ANN ARBOR HISTORIC DISTRICT COMMISSION

Staff Report

ADDRESS: 436 Third Street, Application Number HDC22-1091

DISTRICT: Old West Side Historic District

2 PROPOSED WEST ELEVATION
SCALE: 1/4" = 1'-0"

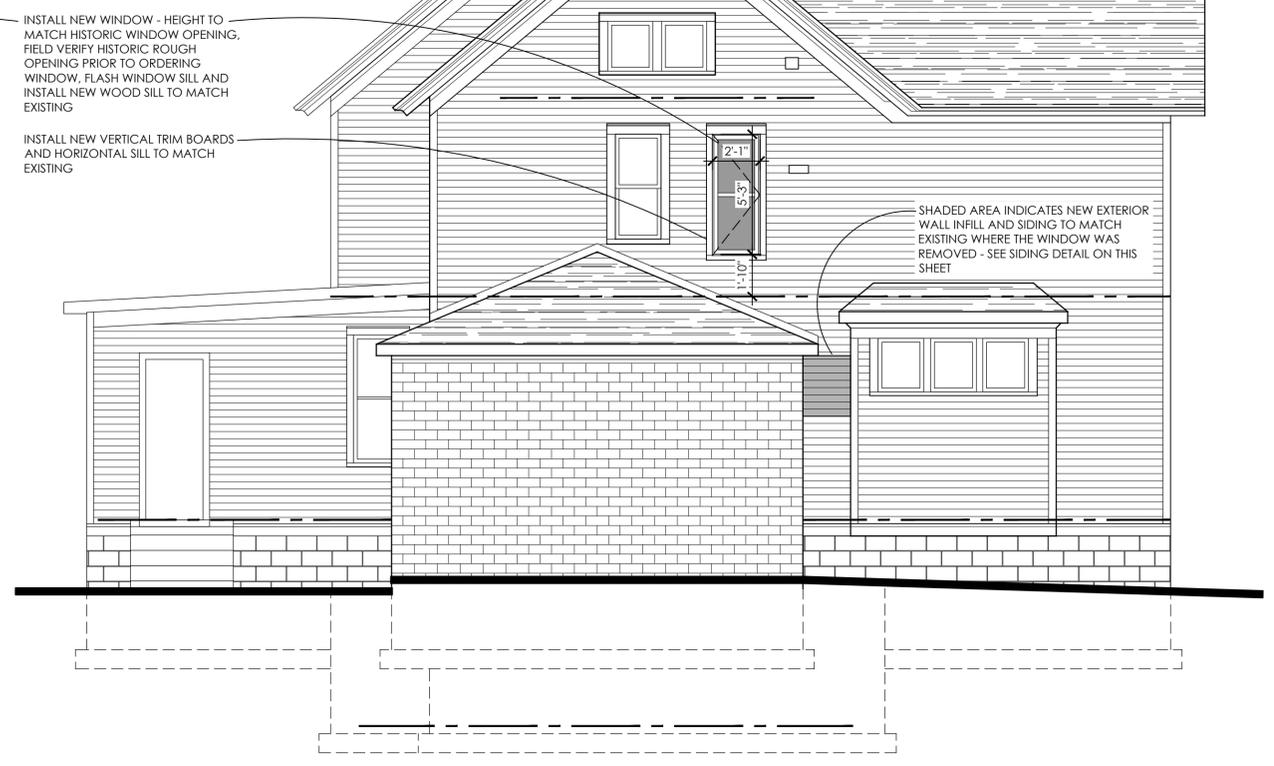
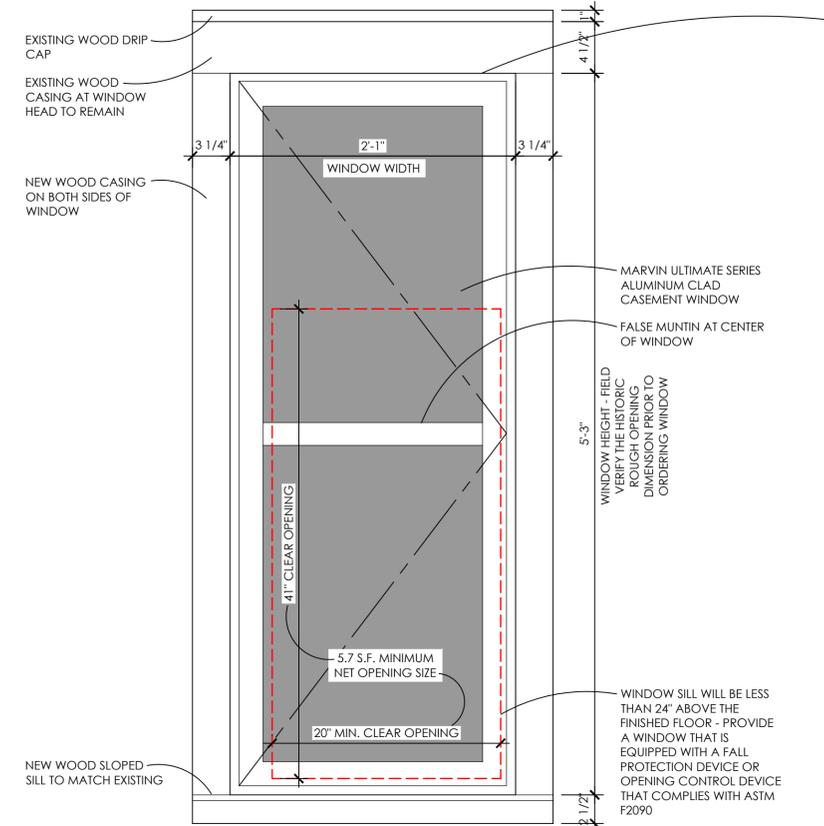
1. Stair Removal: Removing the non-original rear egress stair and restoring the exterior siding is entirely appropriate.

2. Second Story Window Replacement and Enlargement: As it is not appropriate to change the number, location, or size of windows, when such work has been done, it is appropriate to restore a window opening to its original size.
3. First Story Window Removal: This small, awkwardly located window is not original to the building and is appropriate to remove, returning the window and wall pattern closer to its original design.
4. Staff believes that the proposed work meets the *Secretary of the Interior's Standards*, the *Secretary of the Interior's Guidelines for Rehabilitation*, and the *Ann Arbor Historic District Design Guidelines*.

I move that the Commission issue a certificate of appropriateness for the application at 436 Third Street, a contributing property in the Old West Side Historic District, to remove a rear fire-escape stair and restore the opening to exterior, wood-sided solid wall, to replace and enlarge a second-floor rear window to its original opening size and create an egress-compliant window, and remove a first floor rear window and restore the opening to exterior, wood-sided solid wall, as proposed. The work is compatible in exterior design, arrangement, texture, material and relationship to the rest of the building and the surrounding area and meets *The Secretary of the Interior's Standards for Rehabilitation and Guidelines for Rehabilitating Historic Buildings*, in particular standards 1, 2, 9 and 10 and the guidelines for windows; and the *Ann Arbor Historic District Design Guidelines* for windows.
